Form 3160-5
(April 2004)UNITED STATES
DEPARTMENT OF THE INTERIOR
BUREAU OF LAND MANAGEMENTFORM APPROVED
OMB No 1004-0137
Expires: March 31, 2007**SUNDRY NOTICES AND REPORTS ON WELLS***Do not use this form for proposals to drill or to re-enter an abandoned well. Use Form 3160-3 (APD) for such proposals.***SUBMIT IN TRIPLICATE- Other instructions on reverse side.**1 Type of Well ☒ Oil Well ☐ Gas Well ☐ Other2 Name of Operator **BOPCO, L. P.**3a Address
P. O. Box 2760, Midland, TX 797023b. Phone No. (include area code)
432-683-2277

Poker Lake Unit #343H

BOPCO, L.P. respectfully requests the changes listed below to be approved for the above captioned well.

Wellname: BIG SINKS 22, FED 1H, A

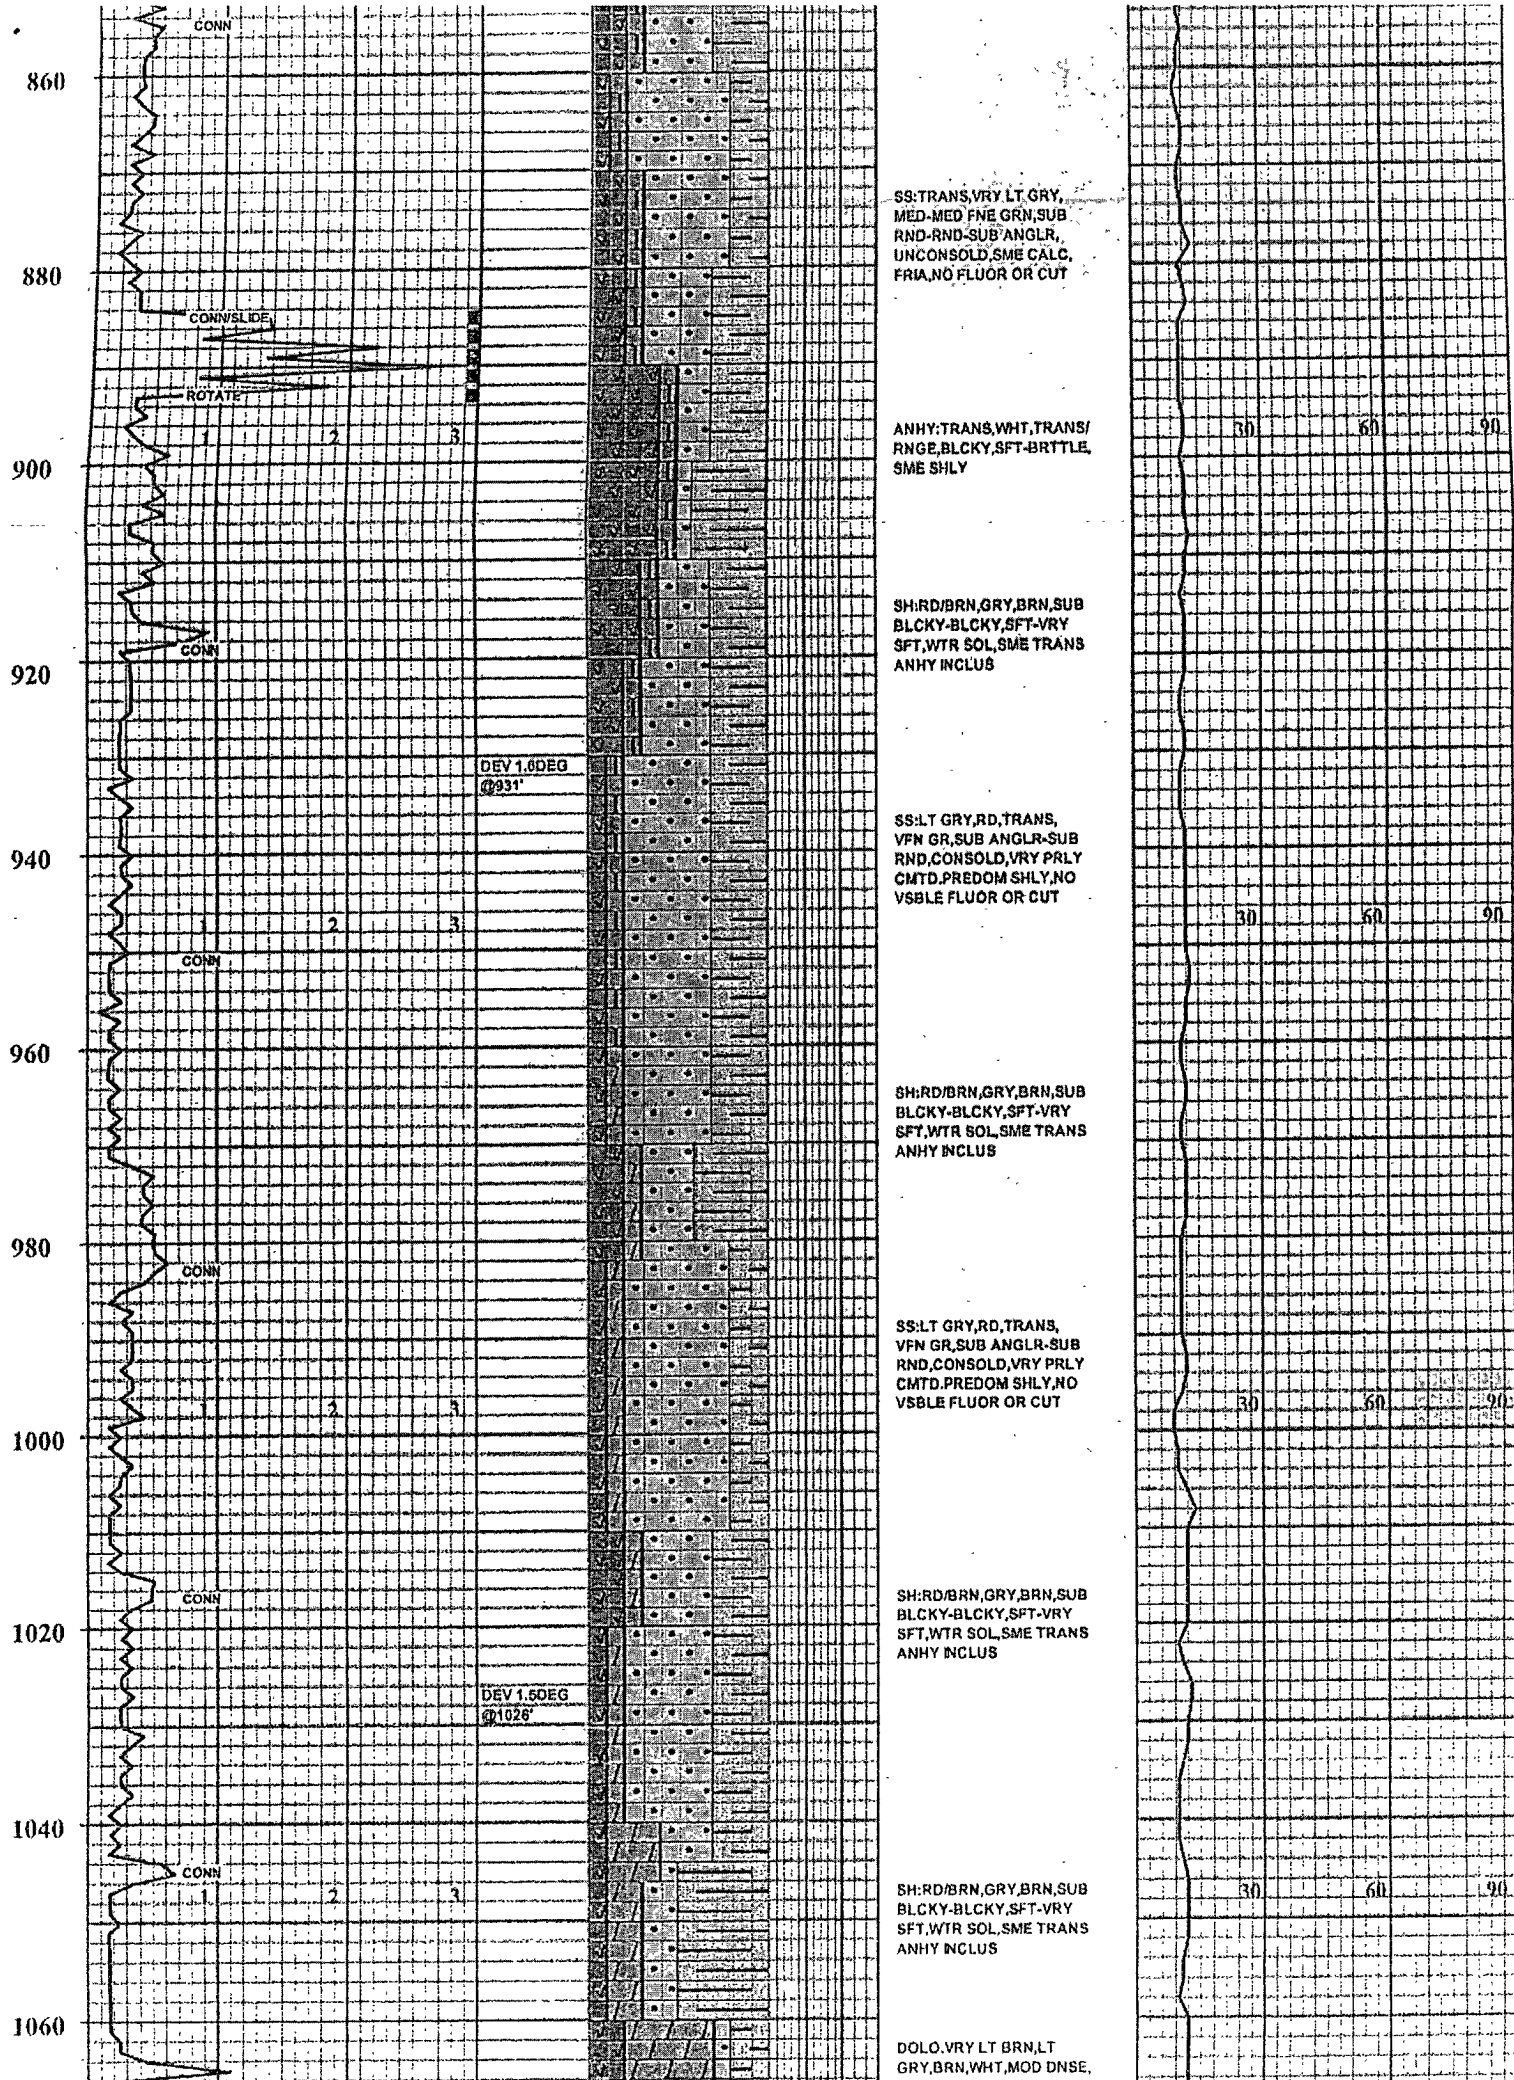
Based on abnormally deep sands with the potential for lost circulation as apparent on the attached mud log, BOPCO, L.P. requests deepening the surface casing set depth currently at 764' to 1260', or wherever competent anhydrite is encountered. If salt is encountered we will cease drilling, pick up 25' and set casing. The PLU 301H (section 27) showed inability to support a 10 ppg mud weight at depths as great as 908'. The attached mudlog is from the PLU Big Sinks 22 Federal 1H whose surface location is approximately 450' away from the PLU 343H.

Updated casing safety factors for 13-3/8", 54.5#, J-55 casing are as follows: BURST - 2.58; COLLAPSE - 1.83; TENSION - 14.45.

Cementing: 1200 sks of Halliburton ExtendaCem - CZ (1.68 ft3/sk; 13.7 ppg).

*Ensure surf. csg is set above the salt.***RECEIVED****AUG 29 2011**
